## Access Compliance Report Public Rights-of-Way (Curb Ramps)

Intersection ID: 3002 Main Street: OLD\_STONEY\_CREEK\_CT Cross Street: WAVERLY\_LYNN\_LN Location: N

ADA ID: ACCCAF5F0A21 Ramp Type: Perp Initial Pass/Fail: Fail Overall Compliance: No Severity Score: 17.5

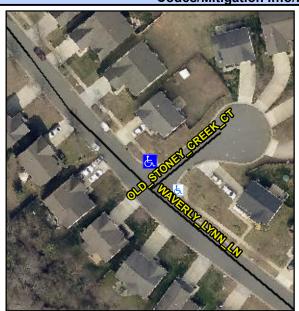
R304.5.1

Field Measurements/Component Compliance					
Compliance Description		Data	Comp	liance Description	Data
N/A	Ramp Length (in)	70.0	Yes	Ramp Slope (%)	5.5
No	Ramp Width (in)	32.0	Yes	Ramp XSlope (%)	1.5
N/A	Flare Type LT	N/A	N/A	Flare Type RT	N/A
N/A	Flare Slope LT (%)	N/A	N/A	Flare Slope RT (%)	N/A
N/A	Flare Traversable LT?	N/A	N/A	Flare Traversable RT?	N/A
N/A	Landing Length (in)	N/A	N/A	DWS Provided?	N/A
N/A	Landing Width (in)	N/A	N/A	DWS Contrast?	N/A
N/A	Landing Slope (%)	N/A	N/A	DWS Length (in)	N/A
N/A	Landing X Slope (%)	N/A	N/A	DWS Full Width?	N/A
N/A	Landing Curb? (Y/N)	N/A	N/A	DWS Offset (in)	N/A
N/A	Shared Landing?	N/A			
N/A	Gutter Ponding?	N/A	N/A	Gutter Slope (%)	N/A
N/A	Gutter Lip Ht (in)	N/A	N/A	Gutter X Slope (%)	N/A
N/A	Painted X Walk1?	No	N/A	Painted X Walk2?	N/A
	X Walk 1 Direction	To SE		X Walk 2 Direction	N/A
N/A	X Walk 1 Width (in)	N/A	N/A	X Walk 2 Width (in)	N/A
	X Walk 1 Slope (%)	1.2		X Walk 2 Slope (%)	N/A

Remove & Replace Entire Ramp.
